# VEHICLE RECALL

**G-02507  
July 2002**

**SUBJECT: VEHICLE RECALL (U.S., EXPORT)  
Lower/Horizontal Clutch Rod Replacement on 4300  
and 4400 Models Built from 10/24/2000 Through  
5/30/2002 with Manual Transmissions.**

**Figure 1: Replace original clutch rod PN: 3544400C91 with turnbuckle.**

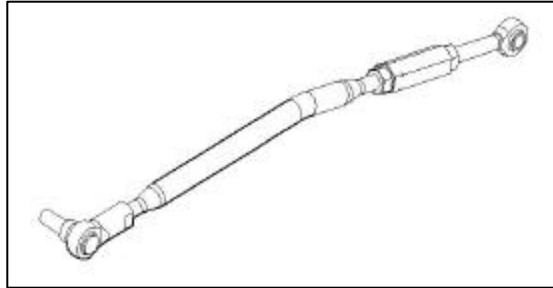
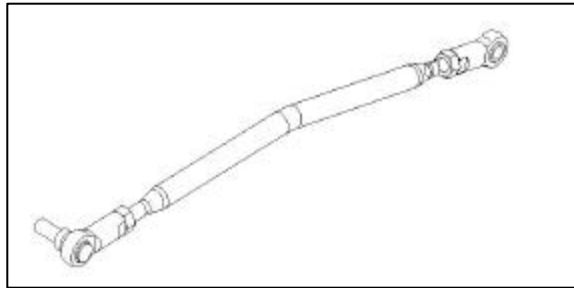
Lower/horizontal clutch rods with turnbuckles may fail from fatigue near the turnbuckle due to bending forces experienced during clutch pedal applications.

**DESCRIPTION:** All vehicles in this recall must have the original lower/horizontal clutch rod replaced. The original rod has a turnbuckle and the new rod does not have a turnbuckle (see Figures 1 and 2 below).

**Figure 2: Install new clutch rod PN: 3532869C91 without turnbuckle.**
